SUBJECT: Highway 9, Orangeville Westerly.

FOUNDATION INVESTIGATION REPORT
For
Hwy. 9, West of Orangeville From
Mid Point of Conc. 3 Westerly
To Conc. 7, Amaranth Twp.
District #3, Stratford
W.O. 73-11075

SETTLEMENT WEST OF ORANGEVILLE

BORE HOLE LOCATIONS & SOIL STRATA

TYPICAL X-SECTION

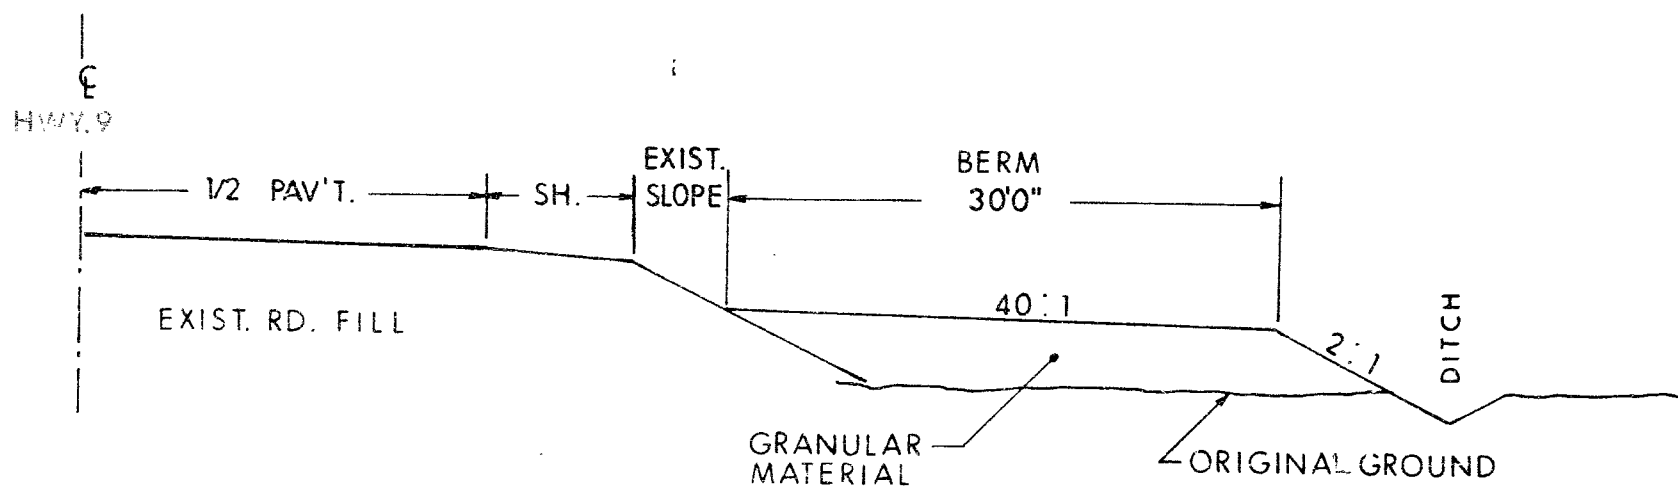
The proposed berms should be half height, up to approximate elevation 1552.0 and placed on both sides of the road. It is recommended that the berms be 30 ft. in length with 40:1 slopes. End slopes of 2:1 will be stable. A transition zone of 50 ft. should be adequate. The ditch may be placed around the berm as required.
